Response to Submissions Section 75W to Concept Plan (MP10_003)

Discovery Point, Wolli Creek

Residential GFA, Above Ground Parking and Design Guideline Amendments

Submitted to Department of Planning and Environment
On Behalf of Discovery Point Pty Ltd and Discovery Point Devt Pty Ltd

Figure 3 – Potential view opportunities

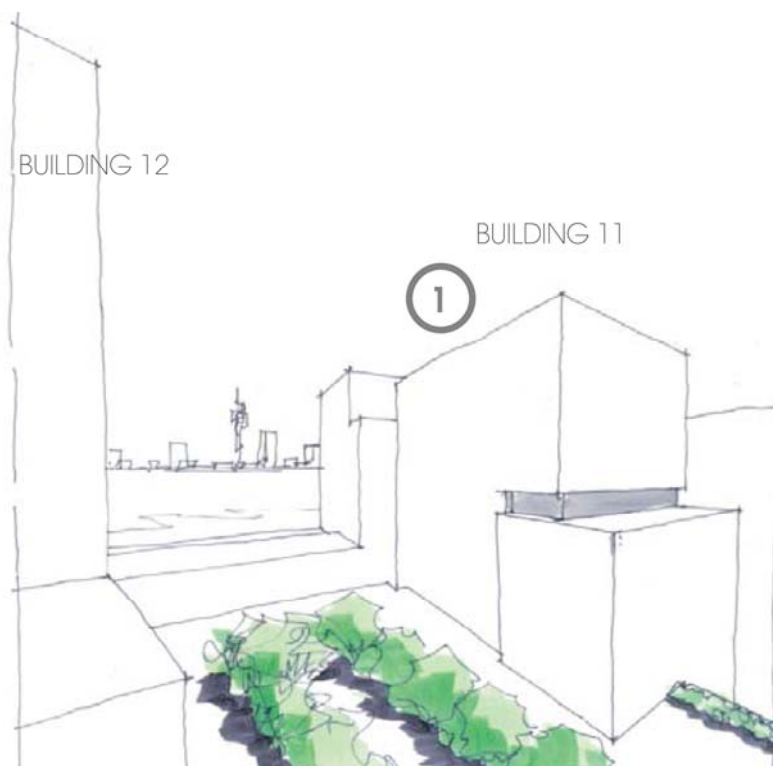
The removal of Building 9 (as approved under Concept Plan Mod 3) has significantly increased the availability of views from Buildings 11, 12 and 13 (Refer to **Figure 3**). The view analysis undertaken by Group GSA and included in the Concept Design Report also demonstrates that there are a variety of high quality views available from Buildings 11, 12 and 13 (refer to **Appendix F**). It appears that Council may not fully appreciate the extensive view opportunities available from these buildings. The proponent also did not fully understand the quality and extent of views until only recently in progressing through the design competition and now detailed design phase.

Daylight to the communal podium within Stages 11, 12 and 13 has also been enhanced through the deletion of Building 9. As such, it is evident that where possible, Australand have sought to improve the design of the development and improve/optimize amenity where possible/available.

Figure 5 – Updated indicative design scheme (section) for Chisholm Street

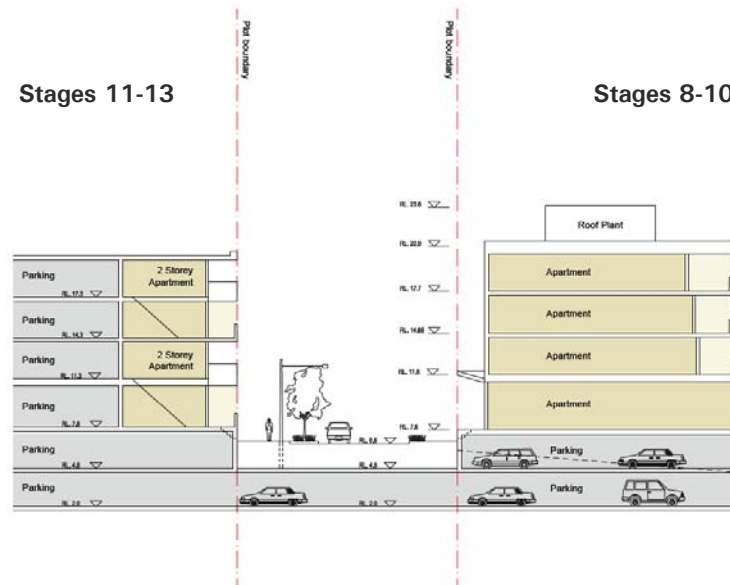
Council contends that any additional parking areas required for the development should be provided through creating additional levels of underground parking. This will ensure that the overall impact on building form and streetscape resulting from above ground parking are avoided. We believe these perceived impacts will be appropriately addressed by “wrapping” the car park with apartments and through other design measures (further details provided below). The Concept Plan Approval currently allows for above ground parking for Buildings 11, 12 and 13 in generally the same location as proposed. The difference lies in an additional two levels of above ground parking being permitted as part of this modification application, which are levels that will be located entirely within the approved podium envelope and will be wrapped with apartments or appropriately screened.

Ultimately, the look and feel of the podium planned for Stages 11 – 13 will be consistent with that of approved Stage 8 – 10, which only included one level of above ground parking (ground), refer to **Figure 5**. So whilst Stage 11 – 13 will have four levels of above ground parking, it will not be readable or contribute to an adverse built form outcome.

Figure 7 – Indicative design scheme public domain interface/features

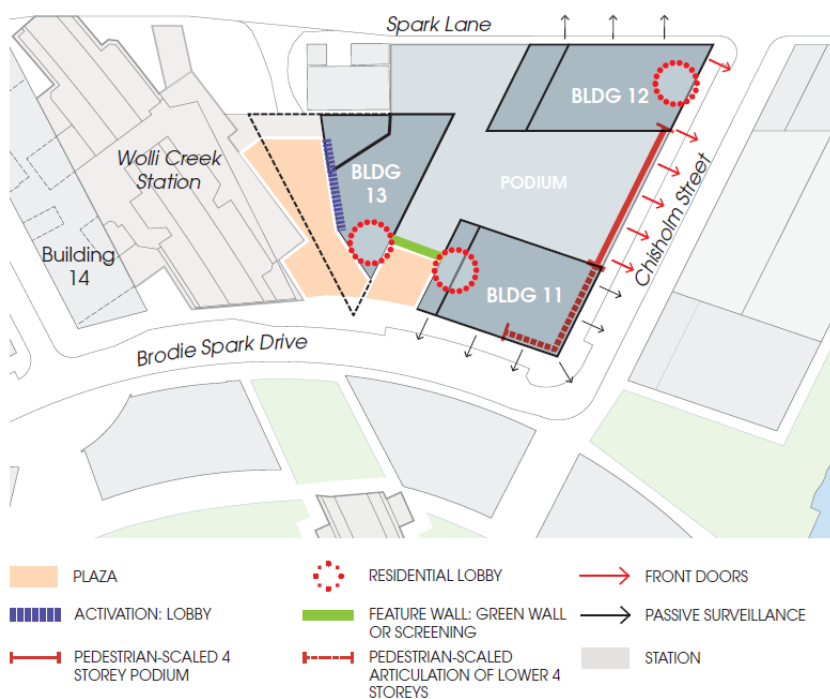
Council in its submission has also identified that the podium levels between Buildings 11 and 13 needs to be carefully considered from an aesthetic perspective. The further development of the indicative design scheme with the appointment of Group GSA has revealed an opportunity to create a lively residential plaza in this location created through the positioning of the lobby for Building 11 and 13 off the plaza (refer to **Figure 7**). The provision of a feature (green or screening) wall to the podium between these two buildings will also add to the character of the streetscape and create a special sense of arrival for future residents/visitors of the two buildings (refer to **Figure 9** and **Figure 8**). The proposed response to the four storey podium is one which seeks to result in a positive outcome from both a design/aesthetic perspective as well as from a human experience perspective.
